Railway Interoperability and Safety Committee

Working document

Draft Commission Decision amending Commission Decisions 2006/861/EC, 2008/163/EC, 2008/164/EC, 2008/217/EC, 2008/231/EC, 2008/232/EC, 2008/284/EC, 2011/229/EU, 2011/274/EU, 2011/275/EU, 2011/291/EU and 2011/314/EU

“Figure N1

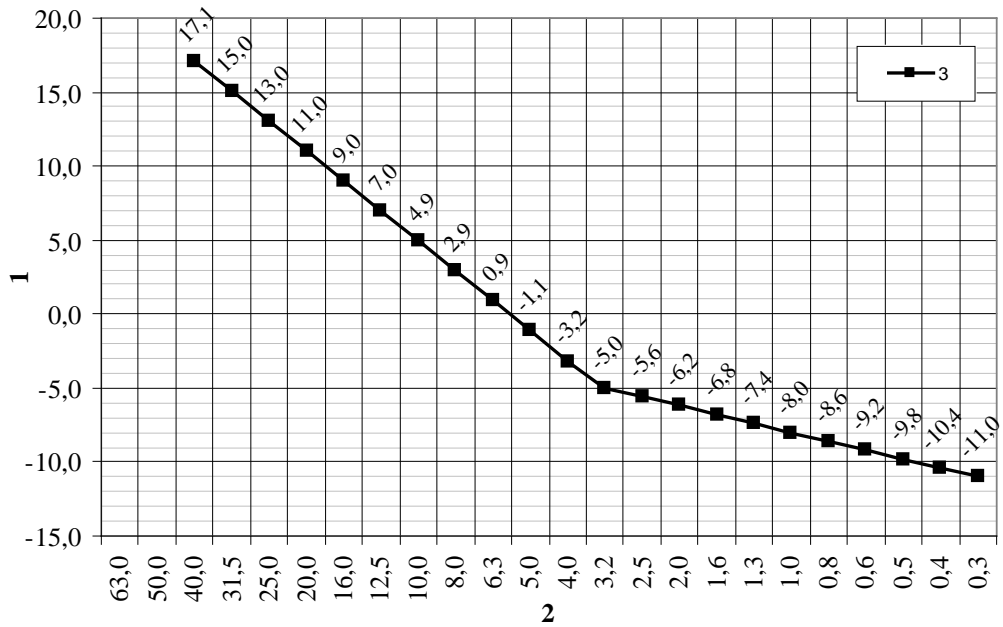
(33) In Annex N, figure N1 is replaced by the following:
